Access Compliance Report

Public Rights-of-Way

Intersection ID: 5741	Main Street: MALLARD_CREEK_RD	Cross Street: NEVIN_RD	Location: SE
ADA ID: 109FB1021AD8	Ramp Type: Perp	Initial Pass/Fail: Fail	Overall Compliance: No
			Severity Score: 21.25

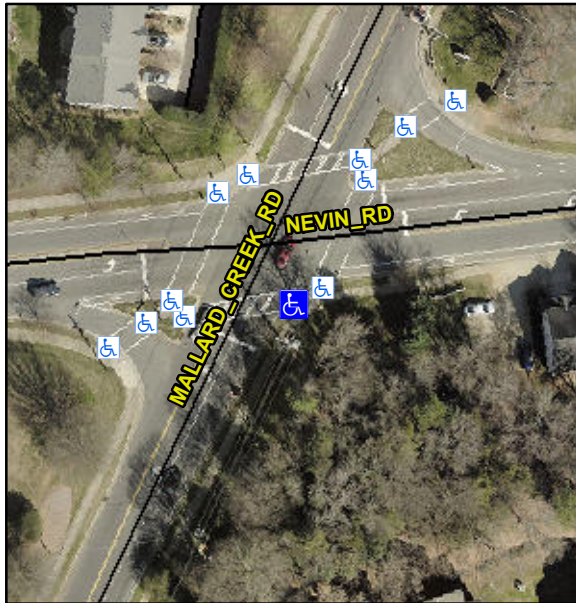
Not Found, R304.5.1, R304.2.2

Compliance	Description	Data	Compliance	Description	Data
N/A	Ramp Length (in)	49.0	No	Ramp Slope (%)	11.8
No	Ramp Width (in)	47.0	Yes	Ramp XSlope (%)	0.2
N/A	Flare Type LT	N/A	N/A	Flare Type RT	N/A
N/A	Flare Slope LT (%)	N/A	N/A	Flare Slope RT (%)	N/A
N/A	Flare Traversable LT?	N/A	N/A	Flare Traversable RT?	N/A
N/A	Landing Length (in)	N/A	N/A	DWS Provided?	N/A
N/A	Landing Width (in)	N/A	N/A	DWS Contrast?	N/A
N/A	Landing Slope (%)	N/A	N/A	DWS Length (in)	N/A
N/A	Landing X Slope (%)	N/A	N/A	DWS Full Width?	N/A
N/A	Landing Curb? (Y/N)	N/A	N/A	DWS Offset (in)	N/A
N/A	Shared Landing?	N/A			
N/A	Gutter Ponding?	N/A	N/A	Gutter Slope (%)	N/A
N/A	Gutter Lip Ht (in)	N/A	N/A	Gutter X Slope (%)	N/A
N/A	Painted X Walk1?	Yes	N/A	Painted X Walk2?	N/A
	X Walk 1 Direction	To W		X Walk 2 Direction	N/A
N/A	X Walk 1 Width (in)	117.0	N/A	X Walk 2 Width (in)	N/A
	X Walk 1 Slope (%)	1.4		X Walk 2 Slope (%)	N/A
	X Walk 1 X Slope (%)	1.2		X Walk 2 X Slope (%)	N/A

Remove & Replace Entire Ramp.
